REVISION A

SERVICE LETTER NUMBER 27

REFERENCE: AD 82-27-03 (Effective December 30, 1982)

SUBJECT: Rajay Turbocharger Model 325E10 Inspection of Turbocharger Turbine Housings P/N TC-60-11 and/or 600510-01, 600510-02.

FIG. 1

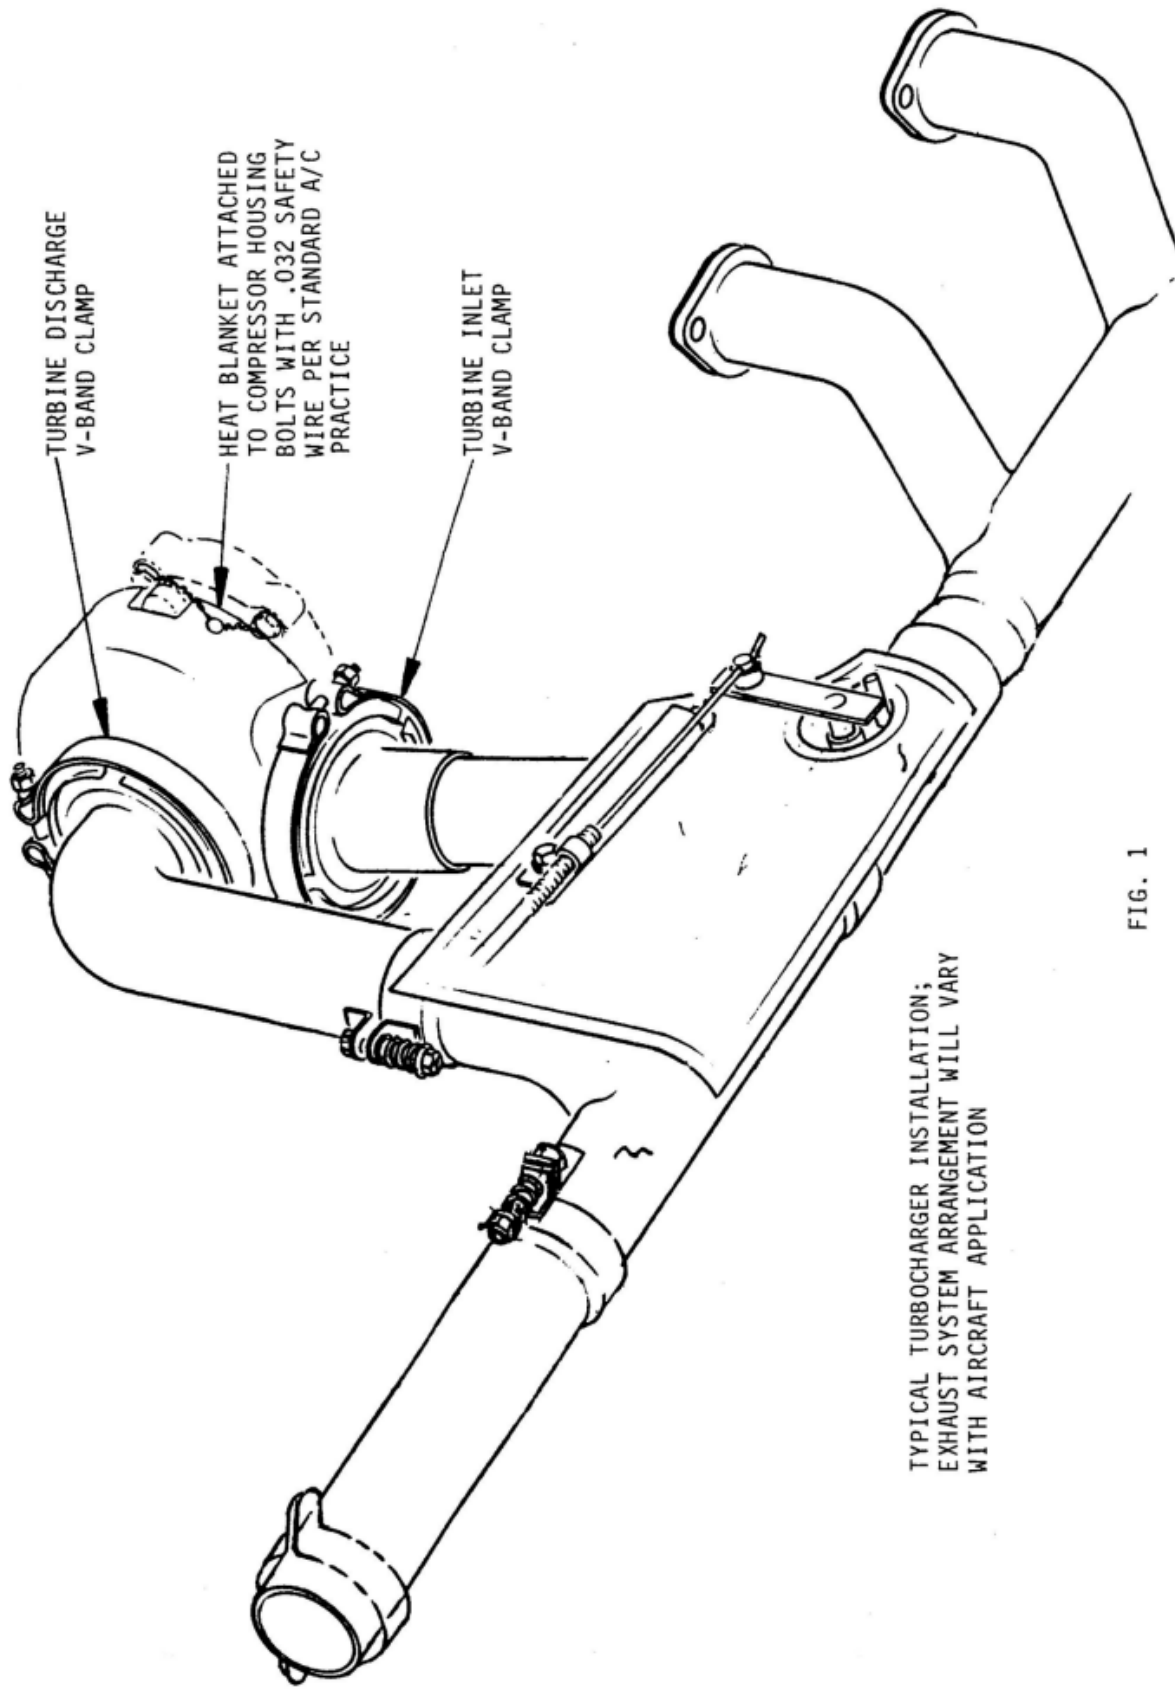
In certain aircraft installations, it may be possible to inspect the turbine housing inner and outer walls for penetrating cracks per Views 1 and 3, without removal of the turbocharger from the aircraft. In any event, the exhaust manifold must be disconnected from the coupling V-band so that the turbine housing internal area near the nozzle can be seen as shown in View 2. If a thermal blanket is installed on the turbine housing, it must be removed. (See Figure 1.)

HEAT BLANKET ATTACHED  
TO COMPRESSOR HOUSING  
BOLTS WITH .032 SAFETY  
WIRE PER STANDARD A/C  
PRACTICE

VIEW 1 Turbine Housing Exhaust Inlet Internal Cracks.

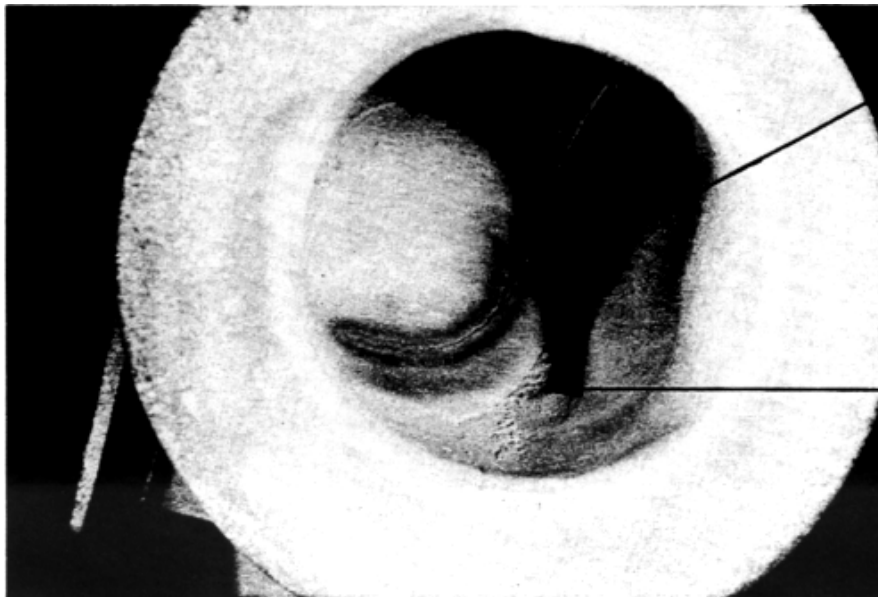
1. Inspection of Turbocharger Installed on Engine - After the initial 50 hours Turbocharger time-in-service operation and/or at next aircraft annual and/or 100 hours inspection, whichever occurs first, and thereafter at every 200 hours unit time-in-service, but not later than May 31, 1983. Visually inspect the Turbocharger turbine housing to ascertain possible presence of cracks penetrating the outer wall as shown in View 3.
  - a. If Outer Wall Is Penetrated - Replace the turbine housing and gasket with a new P/N 600510-04 (TCM P/N 643931\*\*) housing and new P/N 600400-00 (TC-6-30) (TCM P/N 643932\*\*) gasket prior to the next flight.
2. Inspection of Turbocharger Removed from Engine - Visually inspect the turbocharger turbine housing through the exhaust port for presence of cracks as shown in View 1.

Cracks in this area are allowable to a length of .75 inch maximum.

Do not misrepresent the casting parting line in this area as a crack.

FIG. 2 (cont.) TURBINE HOUSING VIEWS

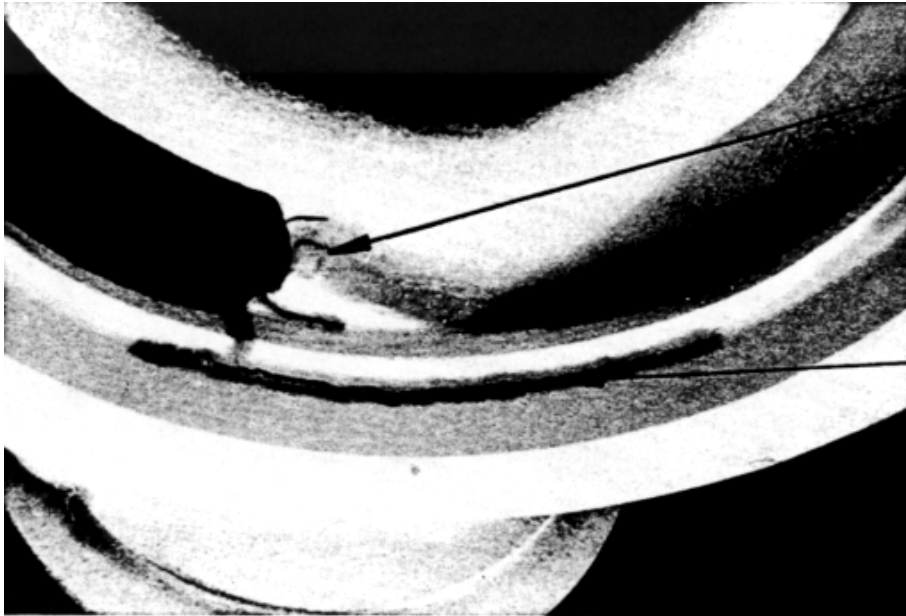
In any case, when a crack penetrates the outer wall of a turbine housing as shown in View 3, the turbine housing and gasket must be replaced prior to the next flight.

Cracks in this area allowable to 3/4 inch.

Cracks in this area allowable to 2 inches.

No cracks of any length in this area.  
If cracked, replace immediately.
